SERVICE BULLETIN SB98.13

Machines/Models:SL20

PURPOSE: To improve brake reliability.

OPERATION REQUIRED: Install relay and additional wiring harness per the following instructions.

Figure 1

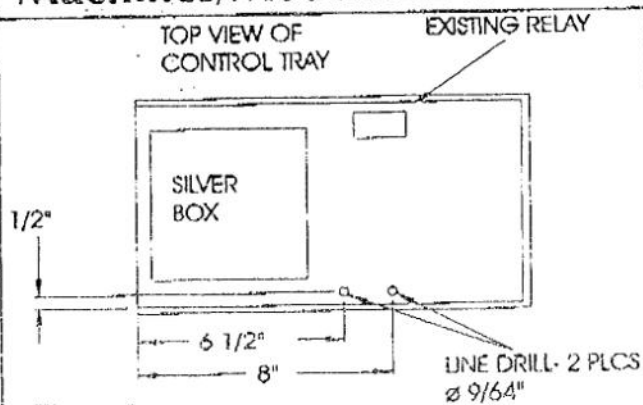
1. Disconnect the negative lead to the battery.
2. As shown in figure 1, drill two 9/64" (4mm) holes and mount Relay (#063951-001) to control tray using supplied attaching hardware (#011715-006 - 6/32 Screw, 2 ea.) (#011248-047 - 6/32 nut, 2ea) and (# 011240-001 - flat washers, 4 ea).

Figure 2

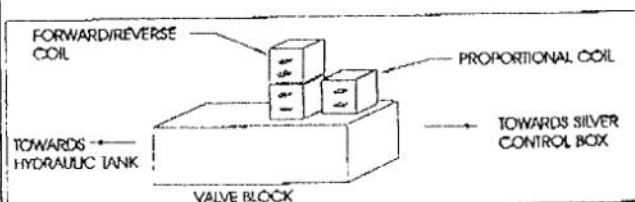
3. Gain access to the wiring by cutting the tie wraps on the loom at the control tray and sliding back the protective covering.
4. Remove the orange/black and orange/white wires from the forward/reverse valve coil (see figures 2 and 3).

5. Connect the new Harness (#101229-000) orange/black wire to the top terminal of the forward/reverse valve coil (see figures 2 and 3).
6. Connect the new Harness (#101229-000) orange/white wire to the third terminal down on the forward/reverse valve coil (see figures 2 and 3).

9. Remove the blue/black or gray wire from the proportional valve coil (see figures 2 and 3).

11. Connect the new wire harness (part # 101229-000) black/red wire to the top terminal of the proportional valve coil (see figures 2 and 3).
12. In the original harness, locate the blue two-conductor cable that connects the manifold harness to the mercury switch (see figure 3).

Figure 3

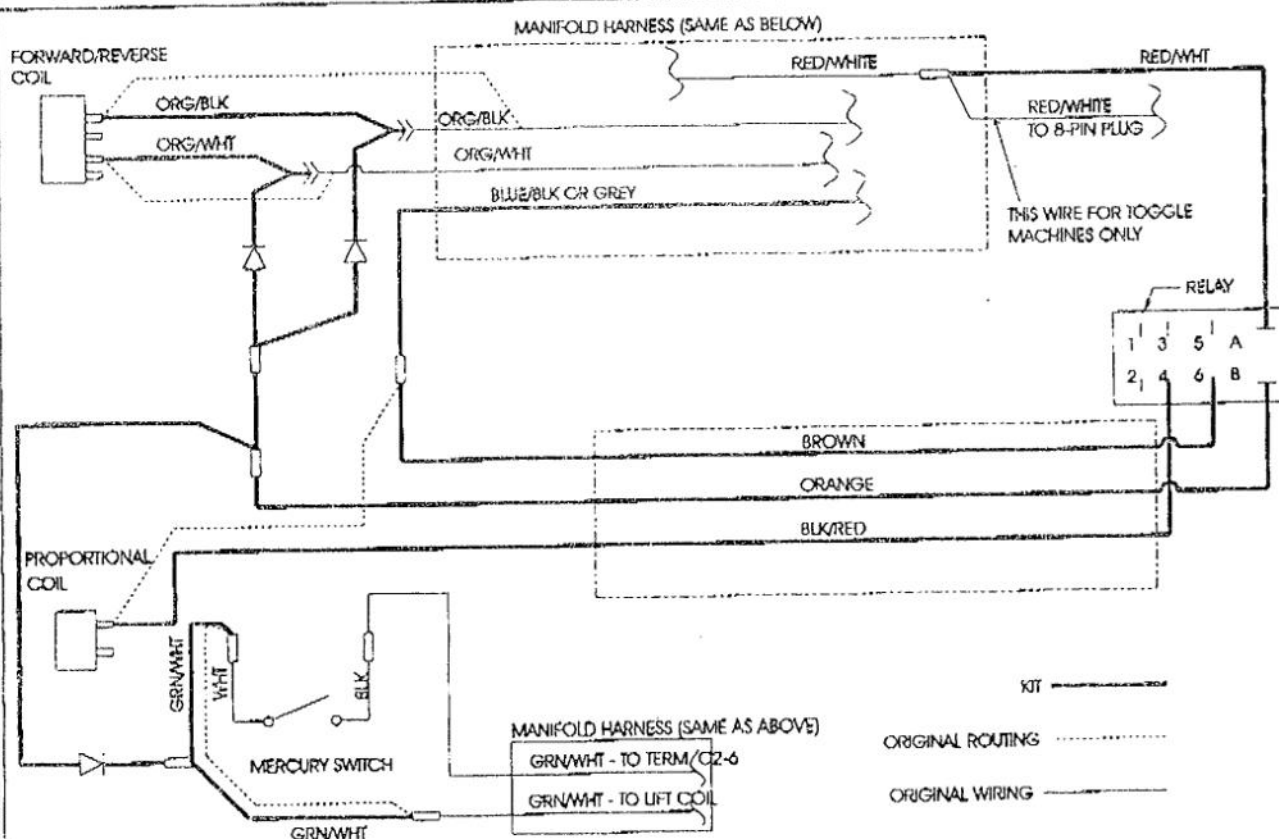
7. Connect the orange/white wire that was originally removed from the forward/reverse coil to the push in connection of the new Harness (#101229-000) with orange/white and orange junction push terminal (see figure 3).

8. Connect the orange/black wire that was originally removed from the forward/reverse coil to the push in connection of the new Harness (#101229-000) with orange/black and orange junction push terminal (see figure 3).

10. Connect the blue/black or gray wire to the brown wire supplied in the new harness (part # 101229-000) using the supplied butt splice (part # 029620-003) (see figures 3).

13. Find the existing splice between the white wire in the blue two-conductor cable and the green/white wire in the manifold harness and remove the splice (see figure 3).

14. Connect the white wire from the mercury switch to one of the green/white wires supplied in the new harness (part # 101229-000) (see figure 3).
15. Connect the green/white wire from the existing harness to the other green/ white wire in the new harness (part # 101229-000) (see figure 3).

16. For Toggle Switch machines splice the red/white wire into the existing harness red/ white wire in a "Y" fashion (see figure 3).
17. For Joystick machines connect the red/white wire in the supplied harness (part # 101229-000) to the red/white wire coming from the manifold harness (see figure 3).

18. Connect the orange wire from the supplied harness (part # 101229-000) to terminal "B" of the relay mounted in step 1(see figure 3).
19. Connect the brown wire from the supplied harness (part # 101229-000) to terminal "6" of the relay mounted in step 1(see figure 3).

20. Connect the black/red wire from the supplied harness (part # 101229-000) to terminal "4" of the relay mounted in step 1(see figure 3).
21. Connect the red/white wire from the supplied harness (part # 101229-000) to terminal "A" of the relay mounted in step 1(see figure 3).
